**City of Bellevue
Development Services Department
Land Use Division Staff Report**

Proposal Name: Bellevue Park Hotel

File Number: **07-143899 LD**

Decisions Included: Design Review with SEPA, Process II

North Elevation

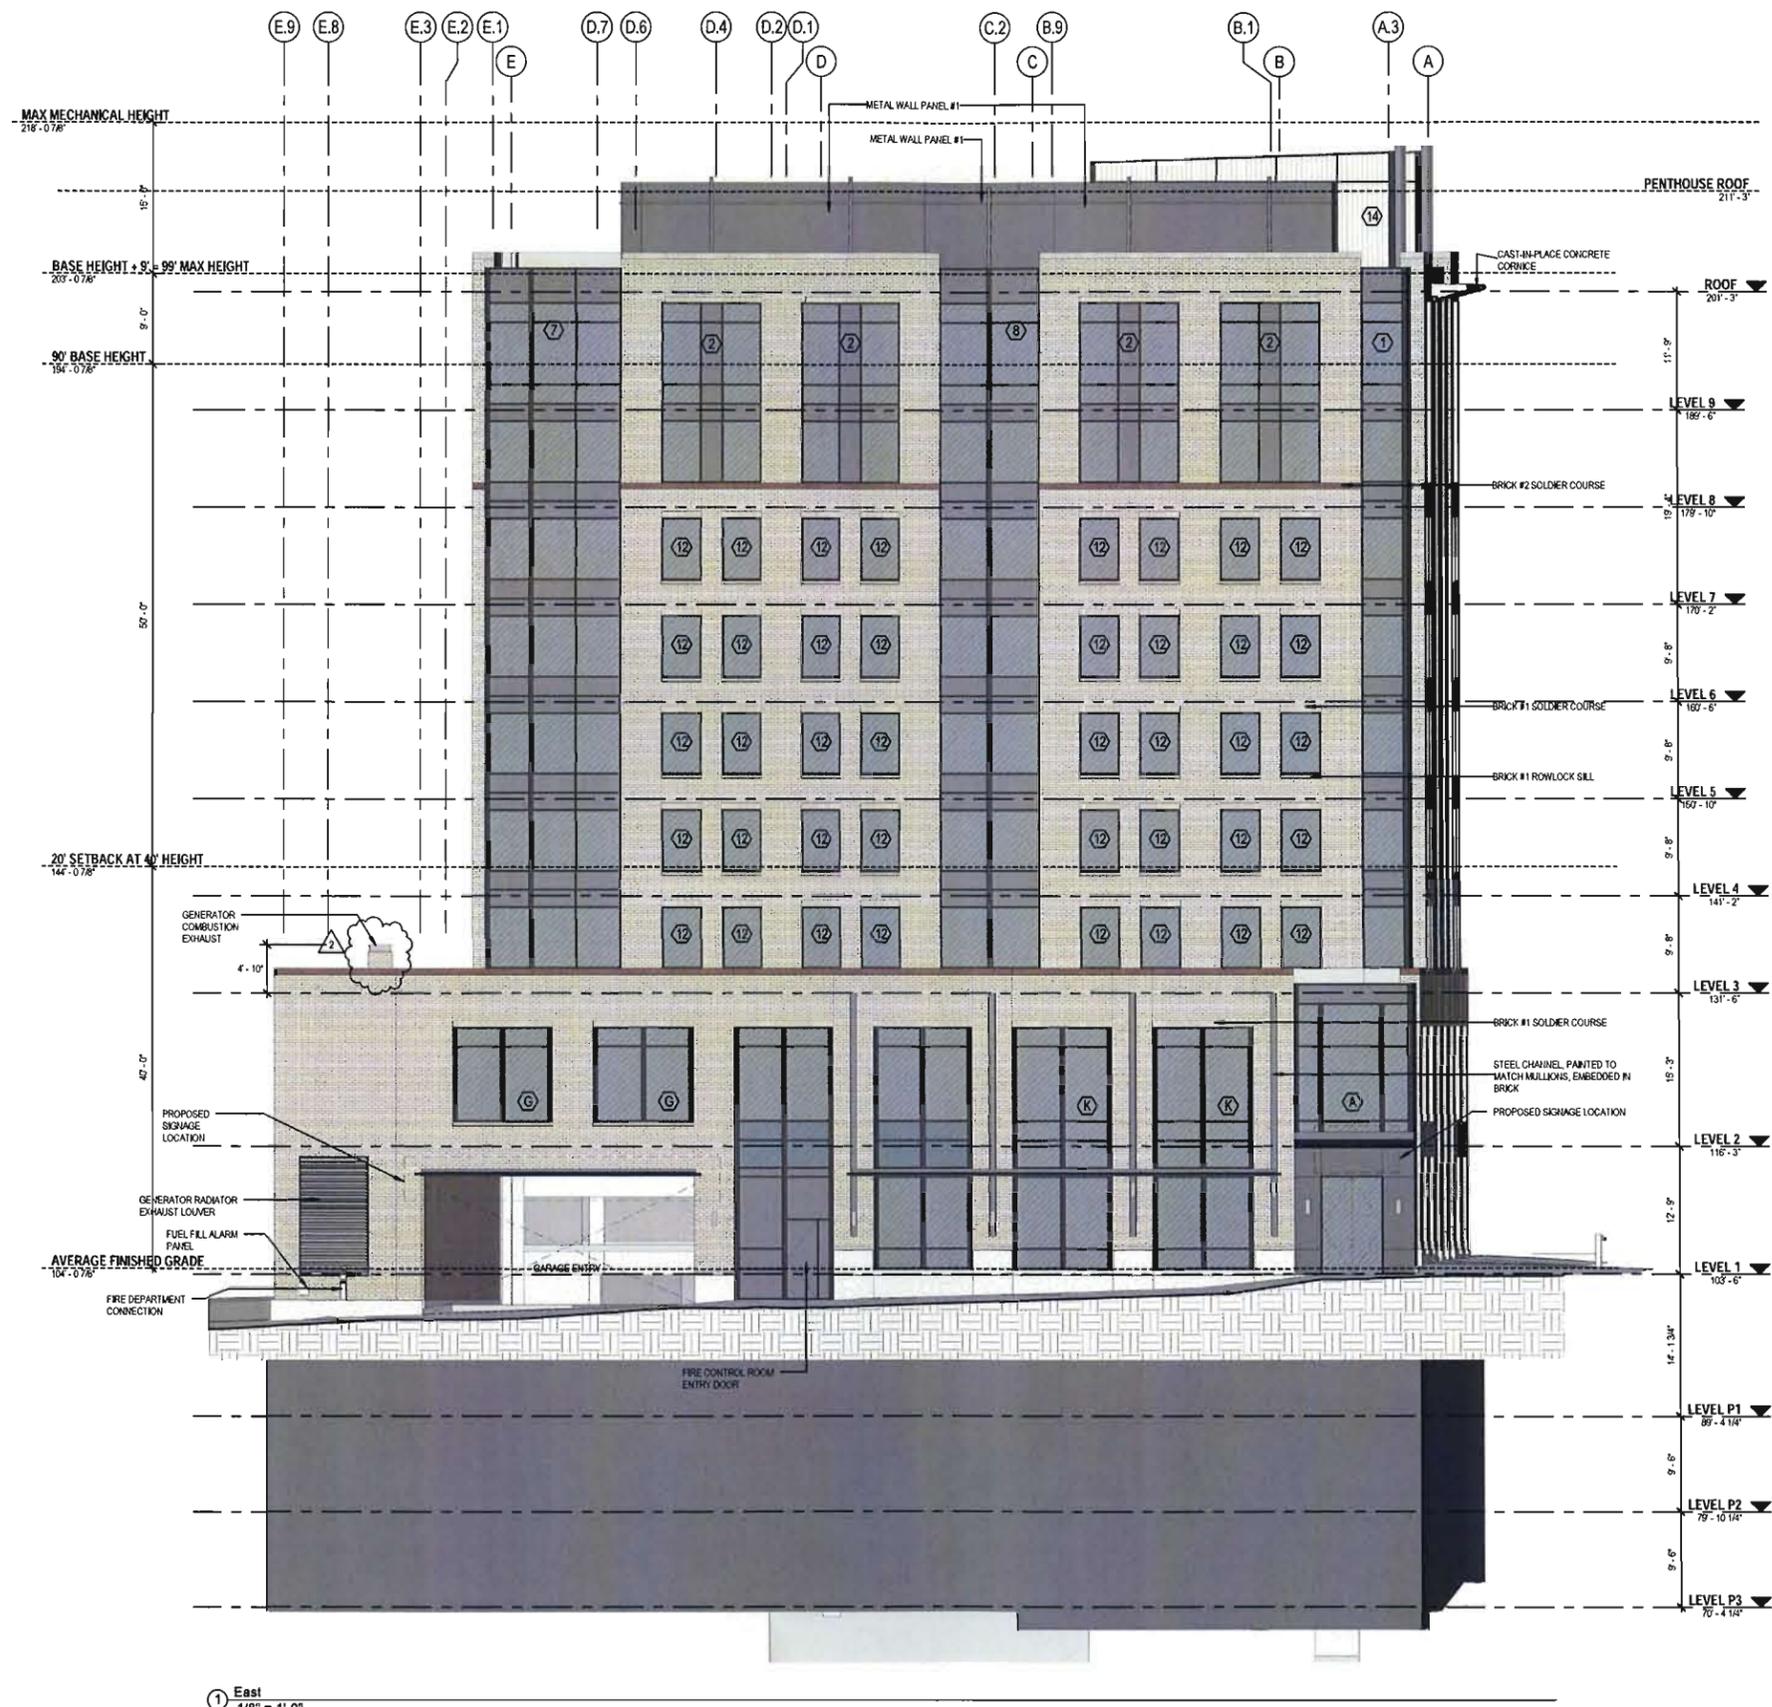
North Elevation (NE 1st Street—See Sheet A3.01): The North façade is the most significant because of its unique relationship to the Bellevue Downtown Park. The façade is vertically proportioned into three central glazed bays articulated by brick pilasters and capped by a projecting metal accent cornice at the roof line. This façade is the most articulated and is intended to present an iconic, memorable façade to the Park.

Response: The building will be clad with one masonry building color as shown on Sheet A3.01. These colors are a weathered tan in color with an accent brick at the top of the building and at various intervals throughout the building body. A dark brown/grey metal panel material will be used for the cornices and mechanical screen. All materials have been proposed to minimize reflected light to comply with the standard above.

East Elevation

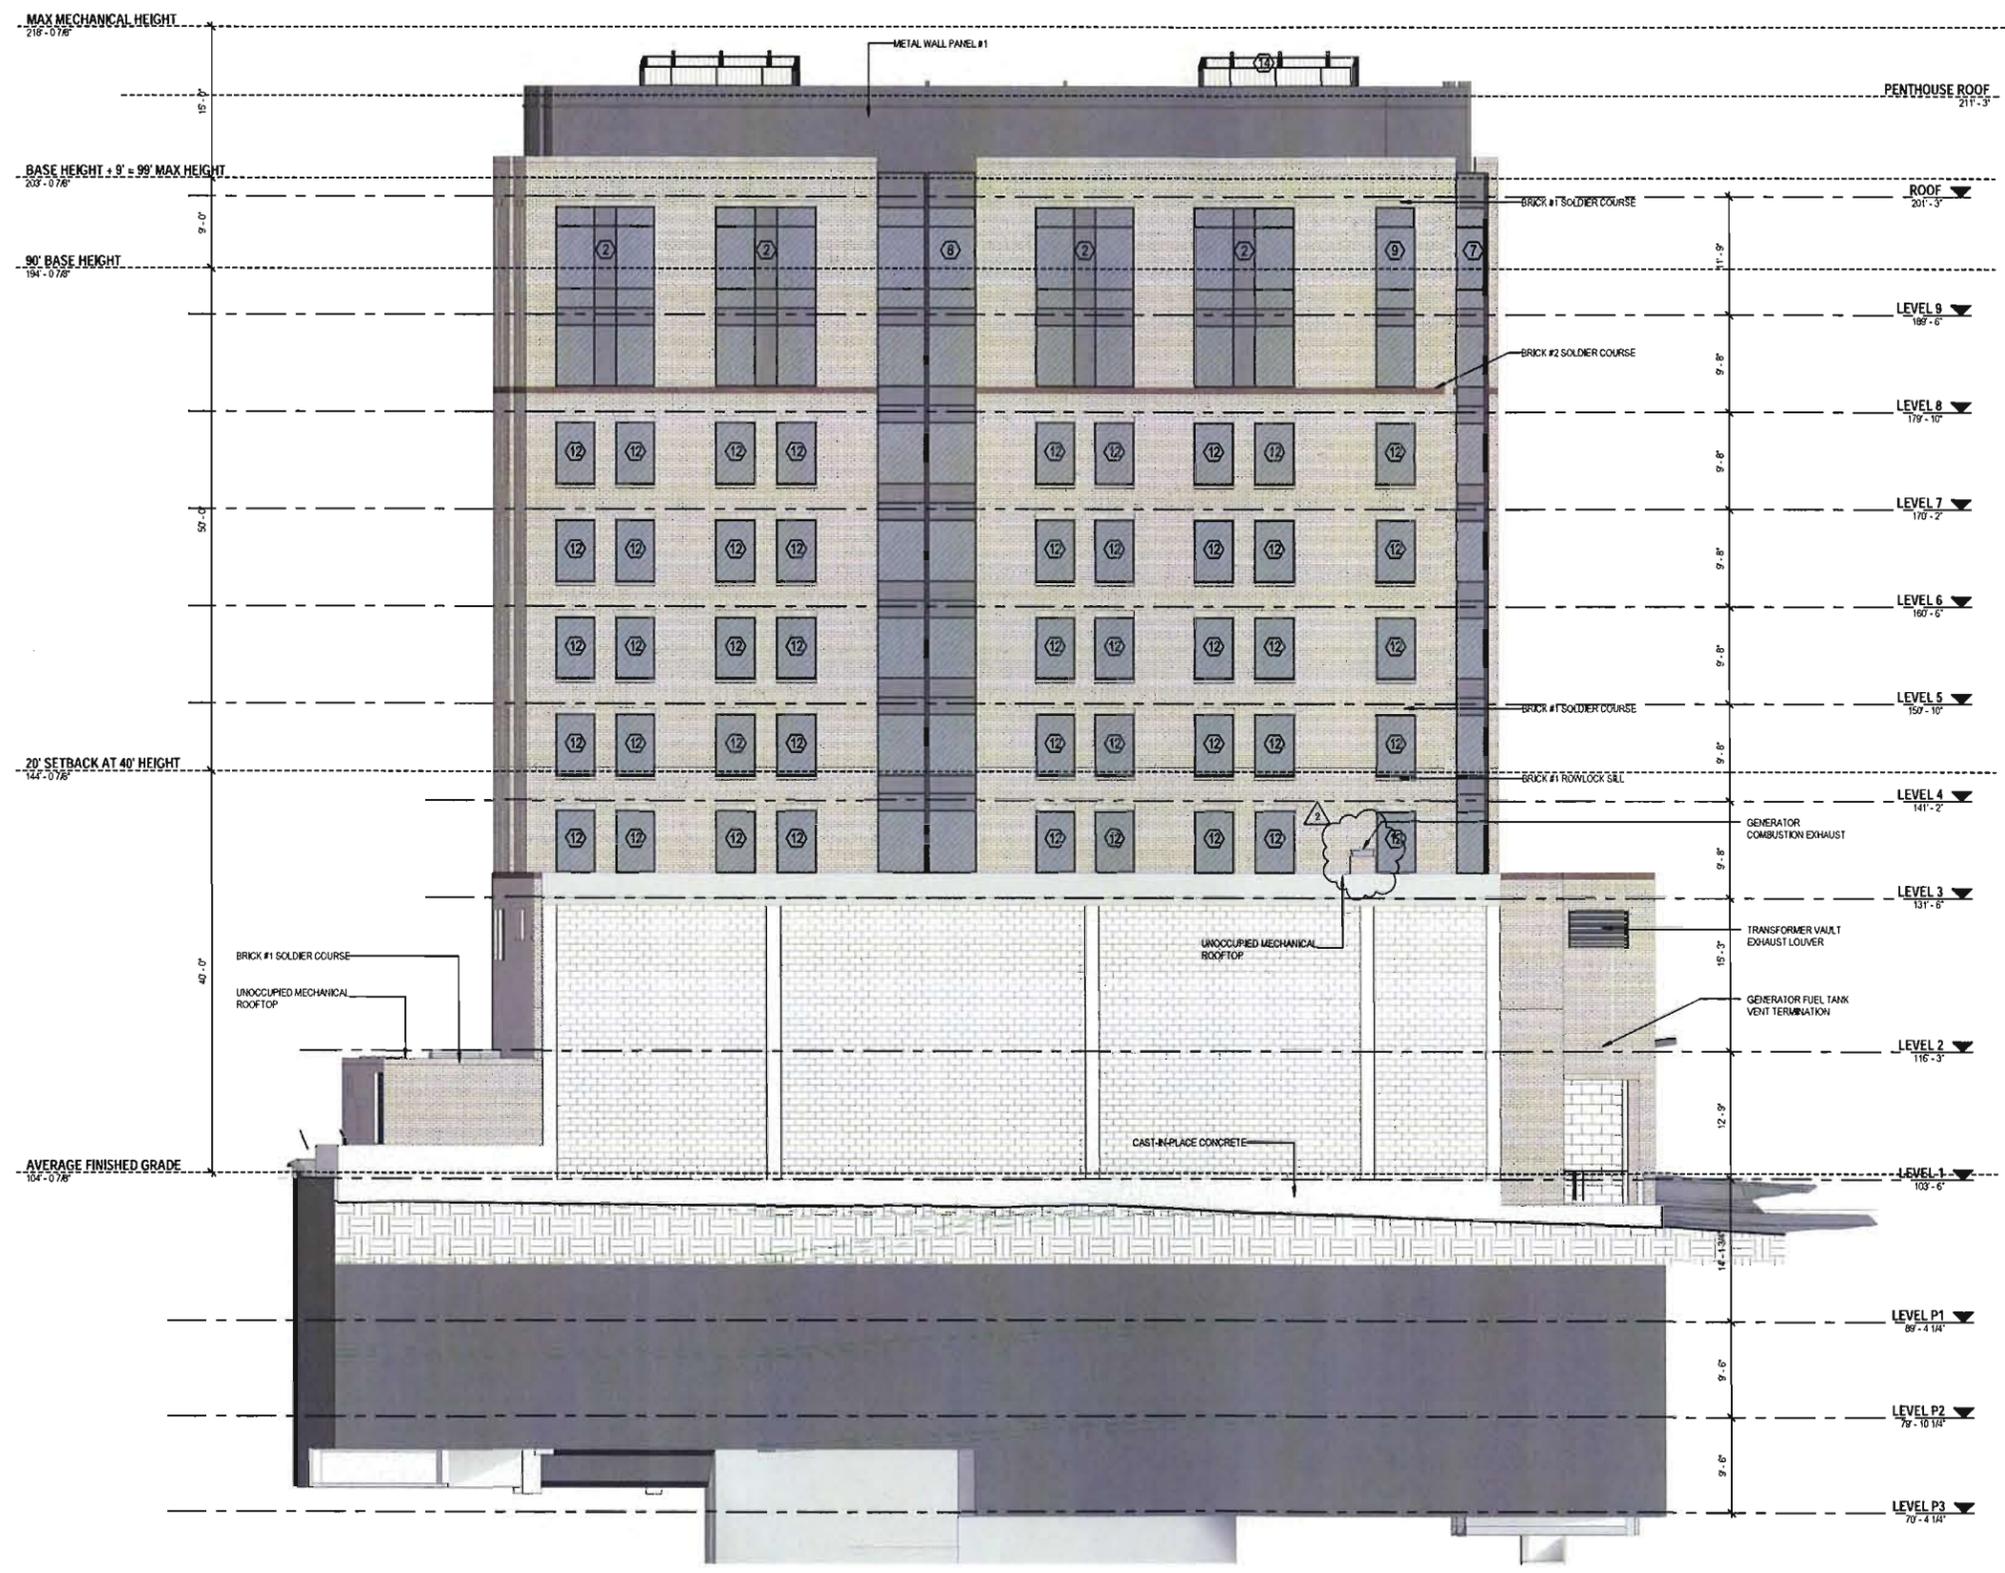
East Elevation (102nd Avenue NE—See Sheet A3.02): The two story podium is set back from the property line 4'-4" to accommodate the required 12' sidewalk. The wall is recessed south of the garage entry, to accommodate a planter located at the SE corner. The fuel fill for the emergency generator is located within the planting area and is accessed by pavers. The heat rejection louver for the emergency generator is located behind the landscaping. The garage entry will conform to all site triangle dimensions. The podium is fenestrated with large windows to connect the activity of lobby, prefunction and banquet room to the street. A series of canopies to promote pedestrian scale will be integrated into the vertically proportioned windows along with a painted cast-in-place concrete plinth and masonry accent texture at the spandrels.

Response: The applicant has proposed a painted cast-in-place concrete base as shown on Sheet A3.02.

South Elevation

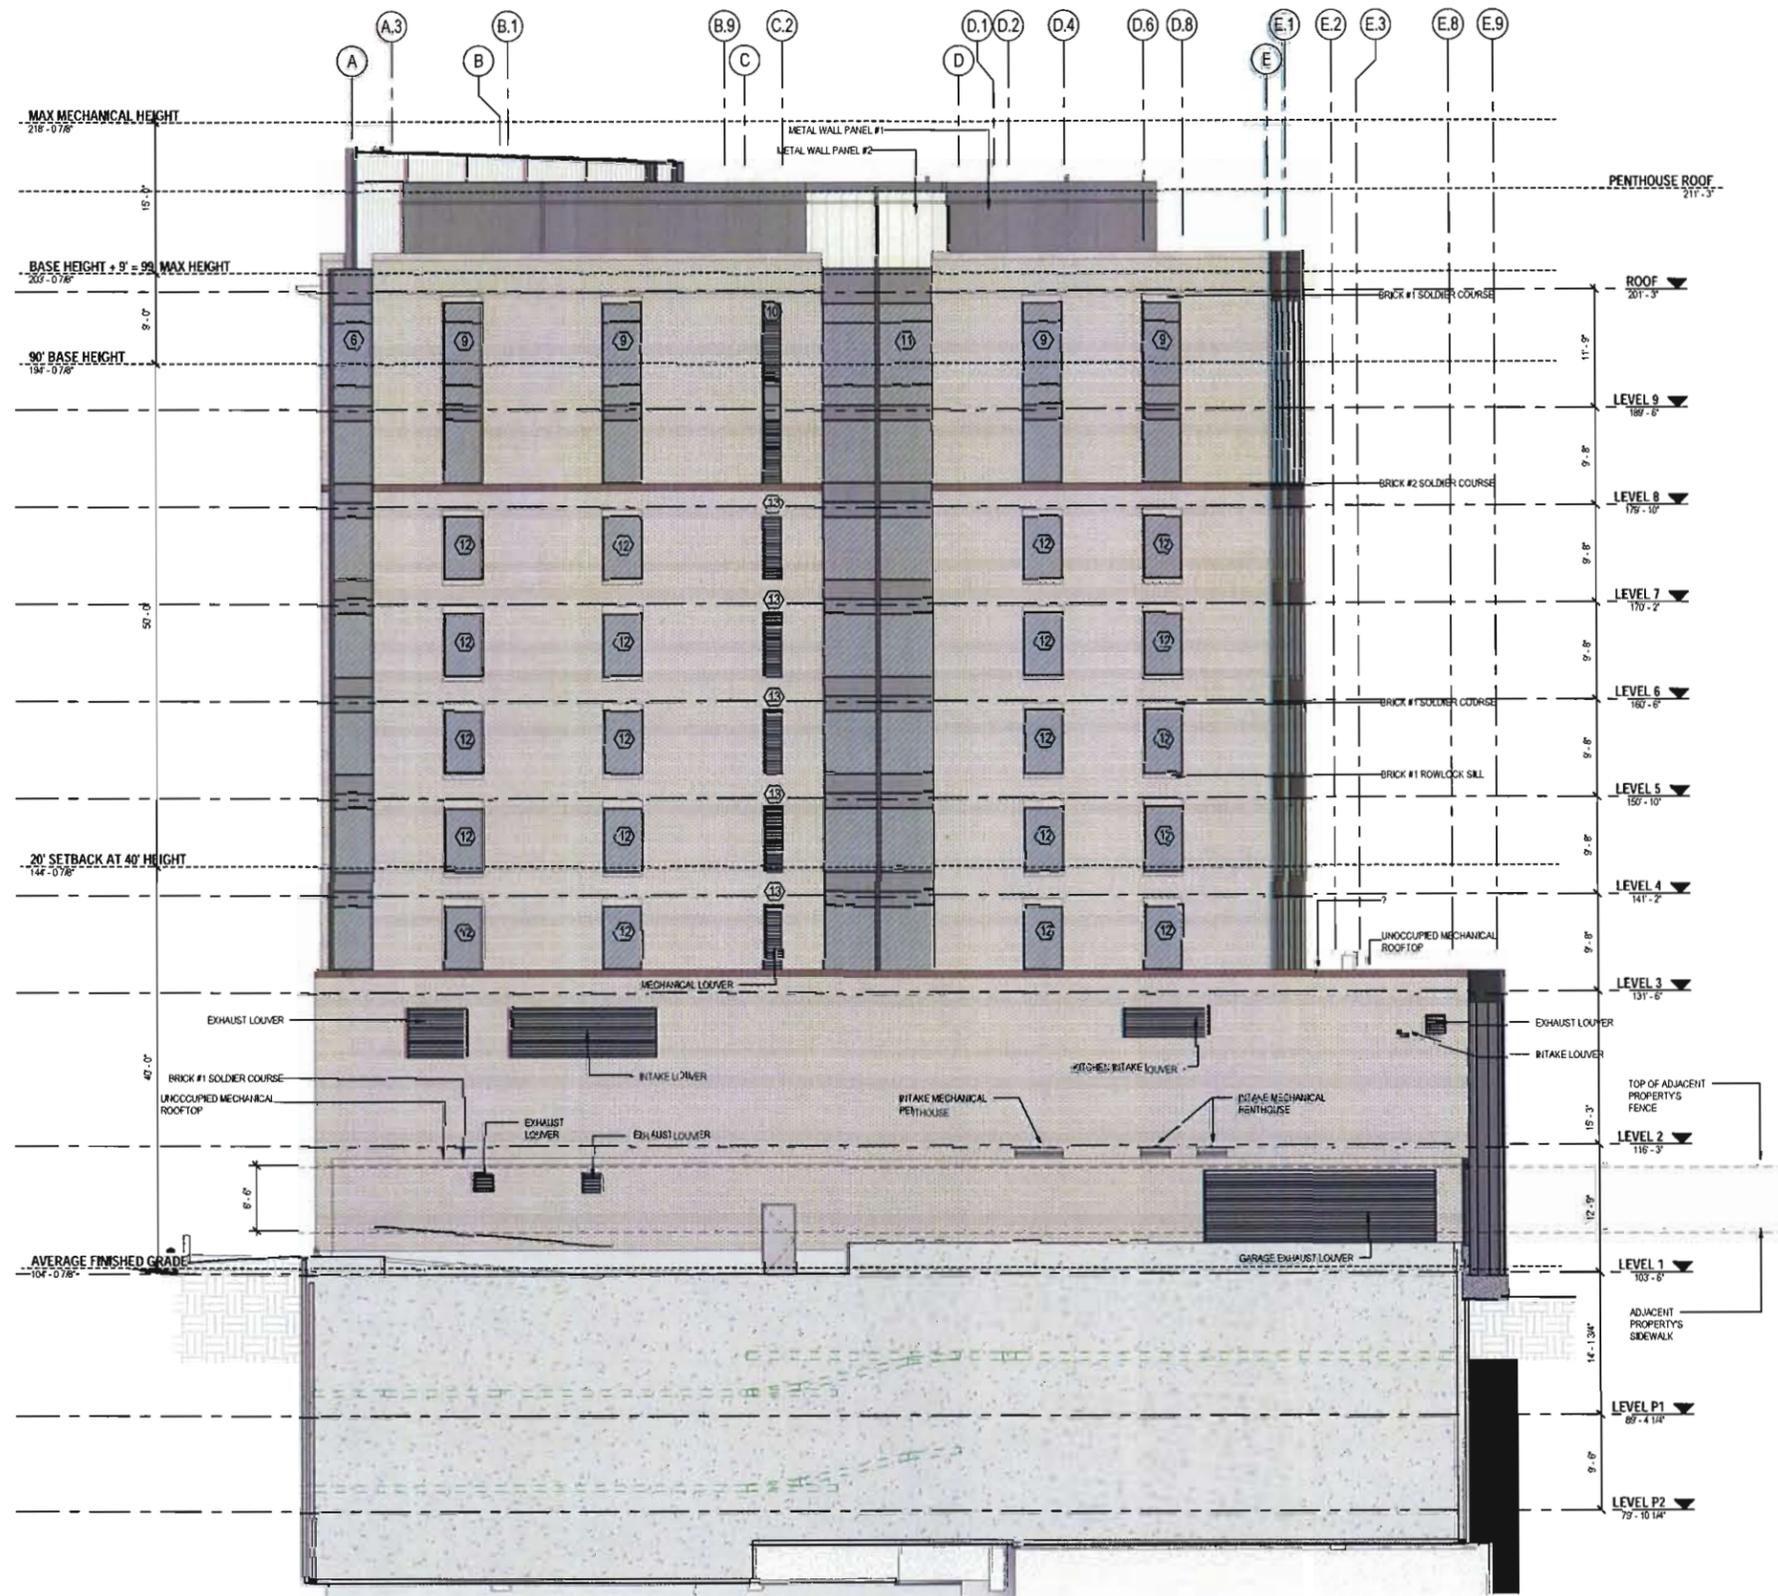
South Elevation (See Sheet A3.03): The first two levels of the south façade are on the property line and comprised of CMU block as infill within the concrete frame. Above level 3 the tower will set back 20' from the south property line. This wall plane continues to the building roof and is stepped back at the mechanical screen wall. The top two floors are differentiated by a continuous band of accent brick string course at the 8th floor. Large double height windows express the 8th and 9th floors and continue vertically to help further articulate the south façade. The façade is separated into two masses by a vertical glazing to proportion the façade more vertically.

West Elevation

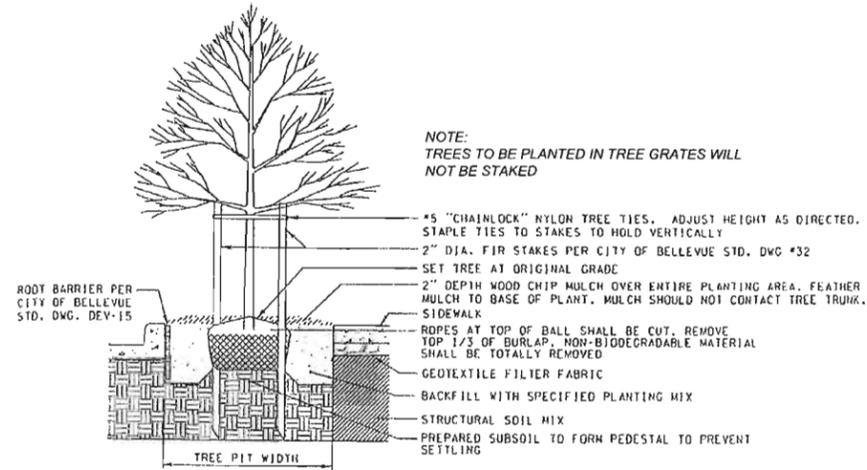
West Elevation (Façade facing McKee—See sheet A3.04): This façade is comprised of a lower one story portion that steps back 5' from the property line and is predominantly blank except for exhaust grilles. The setback allows daylight to penetrate closer to ground plane and provides an exit path for stair discharge. Above level two the building steps back 20' from the property line. The façade is glazed at the NW corner from levels 3 through 9. The primary elevation is separated into two masses by vertical glazing to proportion the façade more vertically. The fenestration is a punched window expression with an accent brick string course at level 8 along with double height punch windows at level 8 and 9 to help accentuate the building's top.

building materials in this vicinity have been upgraded from the initial submission of concrete to a colored masonry as shown on Sheet A3.04.
